MEMORANDUM

BROOKLYN HILL LOW-COST DESIGN PEDESTRIAN CROSSING LOCATIONS

Author(s) Reece Nash
Reviewed Andrew Collings
Entity Transportation
Version V0
Reference BIL-1003220

FIGURE 2. OBSERVED PEDESTRIAN MOVEMENTS

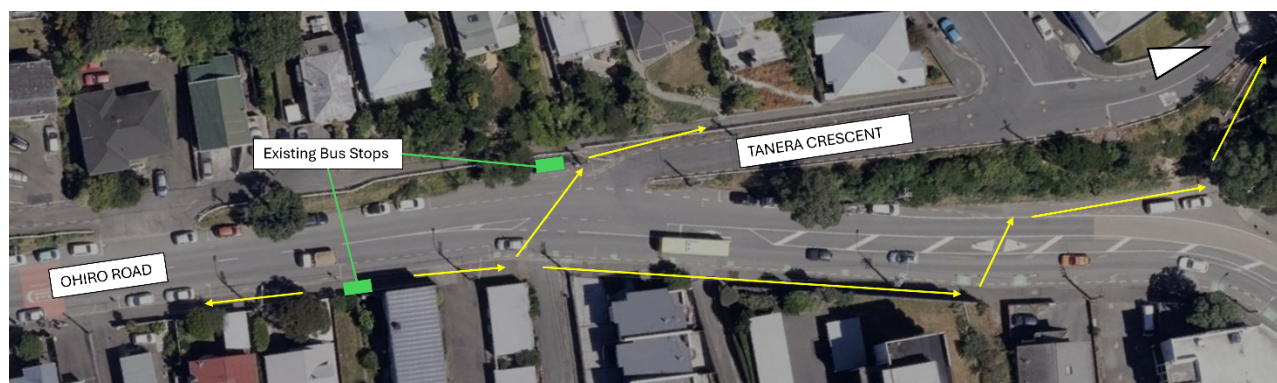
Pedestrian behaviour was observed during the site visit conducted on Thursday 11th of December, between 17:00 and 18:30. At this location, pedestrians were primarily observed disembarking from the bus at the bus stop in the southbound lane. During the site visit, approximately 25-50% of people disembarking the bus at this location crossed the road to go up Tanera Crescent (see Figure 2). At peak, approximately 10-20 people were disembarking the bus at this stop.

A morning peak site visit was not undertaken, though it would be reasonable to assume that people disembarking the bus at this location, would likely also board at this location. This would mean there is also a high proportion of passengers crossing Ohiro Road at this location in the morning as well.

The existing staged non-priority crossing is also the currently designated route to access the footpath along Brooklyn Road, as the footpath on the eastern side of Ohiro Road does not continue onto Brooklyn Road.
